SYDNEY CENTRAL CITY PLANNING PANEL  
COUNCIL ASSESSMENT REPORT

Panel Reference	PPSSCC-742
DA Number	DA/356/2025
LGA	City of Parramatta Council
Proposed Development	Construction of a 7-23 storey residential flat building containing 227 residential units, 3 basement levels providing 269 car parking spaces, earthworks, landscaping, and public domain works. The application is Integrated Development under s90(2) of the Water Management Act 2000. The application is to be determined by the Sydney Central City Planning Panel.
Street Address	29 Hughes Avenue, ERMINGTON & 82-84 Wharf Road, MELROSE PARK NSW (Lot 1 DP1303954)
Applicant	Sekisui House Australia
Owner	SH Melrose PP Land No. 2 Pty Ltd
Date of DA lodgement	15 July 2025
Number of Submissions	2
Recommendation	Approval
Regional Development Criteria	Pursuant to Clause 2 of Schedule 6 of State Environmental Planning Policy (Planning Systems) 2021, the development has a capital investment value of more than \$30 million.

Report prepared by	Darren Wan Executive Planner, City Significant Development
Report date	15 January 2026

**Figure 4.** Ground floor plan of the development showing location of Buildings A, B and C

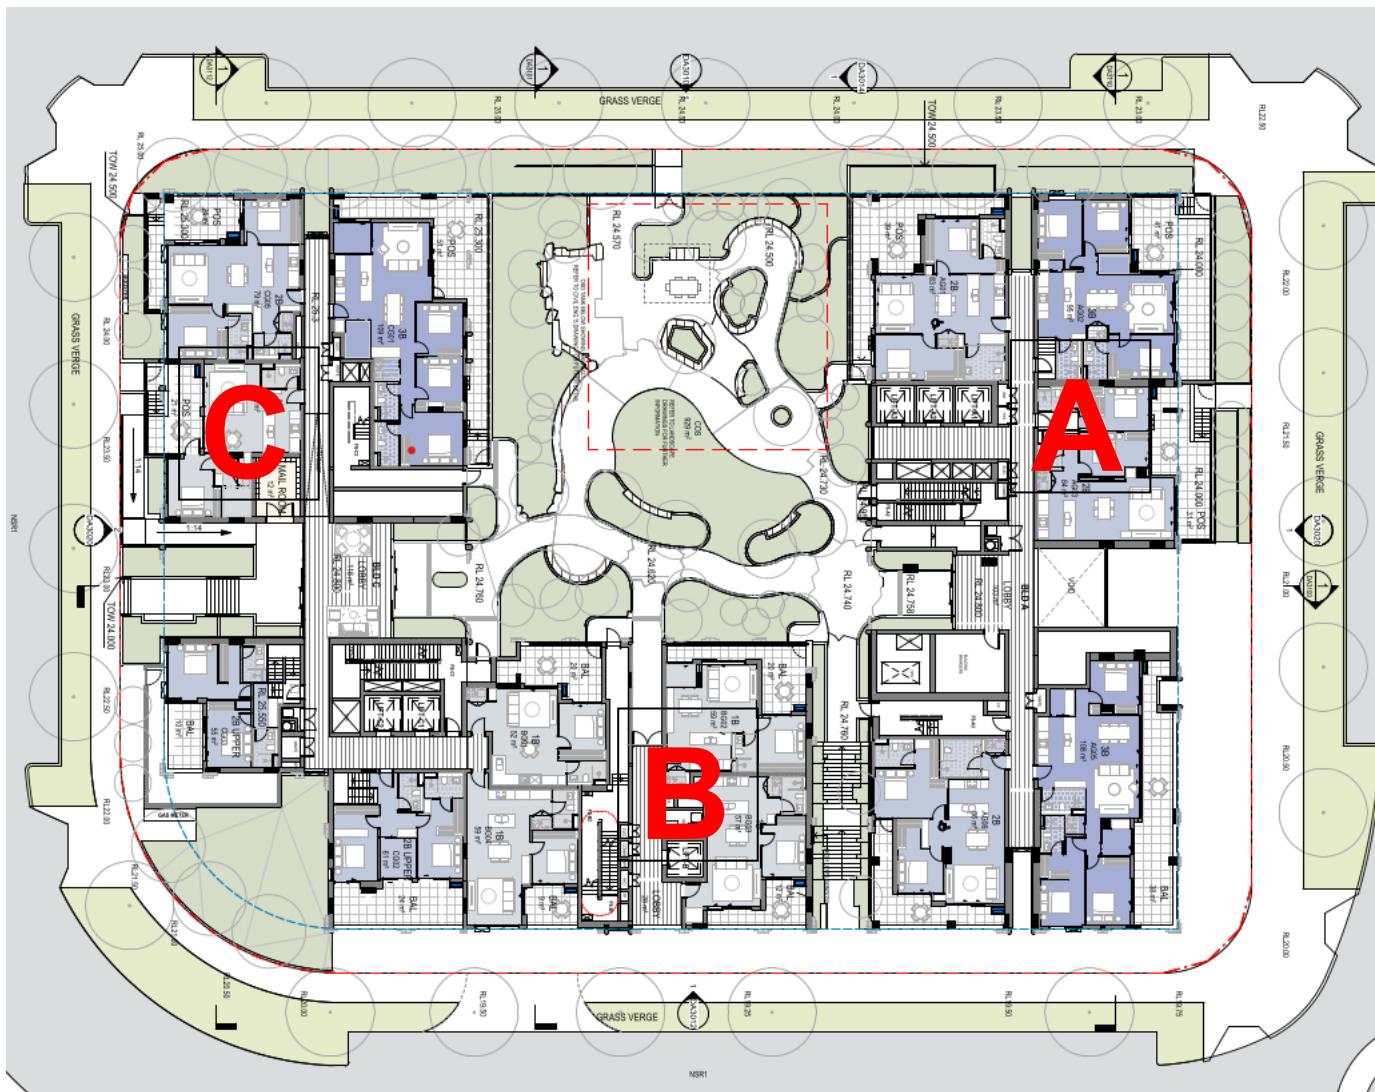
No.	Comments	Applicant Response
1	The Panel supports the rotation of the built form to achieve a north facing courtyard; the resultant massing better accommodates driveway and servicing to the south and improves solar access to the courtyard.	Noted.
2	The Panel also supports the massing and circulation generally, including location of lift cores and through site linking steps; however, greater legibility is recommended throughout the courtyard, where curvaceous paths and extensive raised planters restrict visual and physical access, fail to mediate street landscapes and constrain outdoor amenity.	Landscape design was updated accordingly.
3	The proposal's built form appears very flat, with some sizable areas of blank unrelieved walls and an over-reliance on paint finished precast surfaces – which the Panel does not support. The tower and podium features an excessive amount of unscreened west facing glazing, which is not supported. It is recommended that the materiality of the scheme be substantially reviewed to include integral maintenance free materials such as brick and/or prefinished concrete and well considered screening to full height glazing.	The façade material has been reviewed, with additional pre-finished cladding proposed in areas where blank walls are unavoidable. These include the eastern façade of Building B, the northern façade of Building C, and the south-western corners of Buildings B and C. To further reduce the perceived flatness of these walls, slab projections with capping details have been incorporated.

4.1	The relationship of the podium to the tower element requires greater articulation; without greater differentiation, the podium is not liable to be perceived as street defining at a human scale, as intended by the DCP.	<p>The proposal responds to the design direction recommended by the Design Review Panel, which advised that 'the perimeter block buildings should not have upper-level setbacks on the eastern and western elevations, as such setbacks tend to reinforce the visual dominance of the building unless there is a large setback and clear separation between the tower and podium, such as the model applied in Parramatta CBD'.</p> <p>In line with the DCP and neighbouring developments, the design introduces a "recess level" between the tower and podium levels, where articulation stopped with strong color change. This composition is consistent with the composition established in the neighbouring Lot F development. A change in colour and detailing has also been incorporated to define the</p>

4.2	The northern expression of the western wing is particularly unconvincing (see Renders), with no north facing balconies, applied feature spandrels to painted precast walls and the top two levels not setback but merely given a change in paint colour. It may be better to amend the plans to feature north facing balconies as per the eastern wing, which would also provide additional 3-D modelling.	The apartment type at the north-western corner of Building C has been reconfigured to provide a north facing balcony in line with the DRP's recommendation. For the blank wall portion, panelised prefinished materials are proposed, complemented by slab projections with capping details to introduce shadow and articulation to the façade.

4.3	The Panel notes that the north facing elevation of the southern wing of the courtyard is a much more successful composition, in terms of solid to void and legible bays; this could be used a model to be used more extensively – with integral materials such as brick or dyed concrete.	This comment has been considered in conjunction with item 4.4.

4.4	The legibility and expression of the podium would be improved if it were to extend across the western wing, and setting back the two levels above (perhaps as duplexes) in a different material.	The proposed design changes have considered the recommendations from the DRP, with a detailed response provided in Item 4.1. For Building C, the upper levels incorporate full-height glass panels with a shadow-box detail up to balustrade height, creating a stronger visual distinction between the upper two levels and the lower six levels. An expressed slab-edge projection reinforces the datum line continued from Building B, with this horizontal expression further echoed at the top of the building.

4.5	The single datum line at ground level appears unresolved. It is very compressed at the north west of the built form (making the building appear top heavy and pushed into the ground) and far too high along the southern elevation (thereby emphasizing services and roller shutter – which appears unnecessarily high). It is recommended that the datum be relaxed so that it can appropriately respond to adjacent levels and potential proportions	The datum line is continued from the adjacent Lot F development to maintain a consistent street wall composition. Relacing the datum would result in irregular shifts between orientations – and in some cases multiple breaks within the same frontage – which would be difficult to reconcile in the upper-level design. To support this outcome, one apartment has been repositioned above the loading area, reducing the loading entry to its functional height.
5	The prominent south-west corner is unresolved at present and instead appears like a back-of-house service space. The Panel recommends that the boundary wall be regularised, services better housed and the resultant open space be more purposefully accessed and landscaped.	Fire booster relocated off the south-west corner. Boundary wall regularised as DRP suggested.

8.1	The entry door to unit C0404 and below should be relocated so as not to be in front of elevators	The layout of Unit C0404 and the units below has been revised to relocate the entry door away from the lift lobby.

8.2	Units C0401 and C0408 and below would be improved if they incorporated north-facing balconies	Unit C0408 and below have been revised to have north facing balconies.  Unit C0401 and below remains unchanged to retain a consistent presentation to the courtyard.

8.3	There may be privacy issues between the west facing window to C0404 and below and adjacent window at the end of the access corridor	The size of privacy vertical battens in front of the corridor-end window has been increased to further protect the privacy of Unit C0404 and those below.

<p>six-storey street wall.</p> <p>As part of the RFI response, additional capping and slab projections have been integrated within the podium façade articulation zone, while a stronger colour contrast between the tower and podium façades further enhances visual differentiation.</p>
